# 5.0L WITH A/C COMPRESSOR DRIVE STRETCHY BELT CONFIGURATION—LIGHT LOWER-END ENGINE KNOCK

TSB 12-8-14

**FORD:**  
2011-2012 Mustang

This article supersedes TSB **12-8-3** to update Part List.

Figure 1 - Article 12-8-14

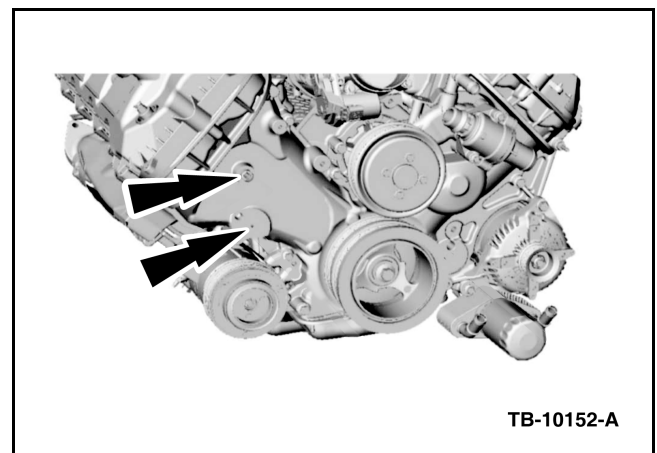
b. If engine build date is after 4/15/2011, do not replace the engine front cover. Use an 8 X 1.25 mm tap to clean the mounting locations noted on the engine front cover. (Figure 1) Use compressed air to clean any remaining debris.

Figure 2 - Article 12-8-14

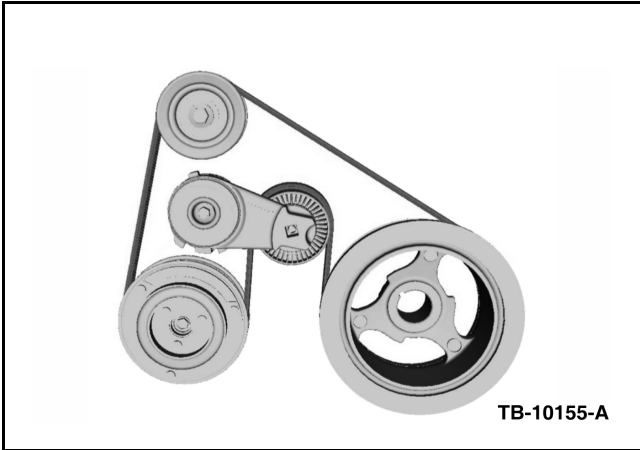
4. Replace the engine front cover. Refer to WSM, Section 303-01.
5. For vehicles with automatic transmission, install new transmission fluid cooler tubes. Refer to WSM, Section 307-02.
6. Install A/C compressor drive belt idler pulley and A/C compressor drive belt idler pulley bolt supplied in the service kit. Tighten to 25 N•m (18 lb-ft). (Figure 2)

7. Install A/C compressor drive belt tensioner supplied in the service kit. Tighten to 25 N•m (18 lb-ft). (Figure 2)
8. Install A/C compressor drive belt supplied in the service kit. (Figure 2)
9. Install accessory drive belt. Refer to WSM, Section 303-05.
10. Install Integrated Diagnostic System (IDS) and identify the vehicle. Answer the IDS screen prompts according to the current vehicle A/C belt configuration.
11. Reprogram the Powertrain Control Module (PCM) using IDS release 79.03 or higher. This new calibration is not included in the VCM 2012.5 DVD. Calibration files may also be obtained at [www.motorcraft.com](http://www.motorcraft.com).
12. Perform Misfire Monitor Neutral Profile Correction. Select IDS Toolbox Icon, Powertrain, Service Functions, then Misfire Monitor Neutral Profile Correction.
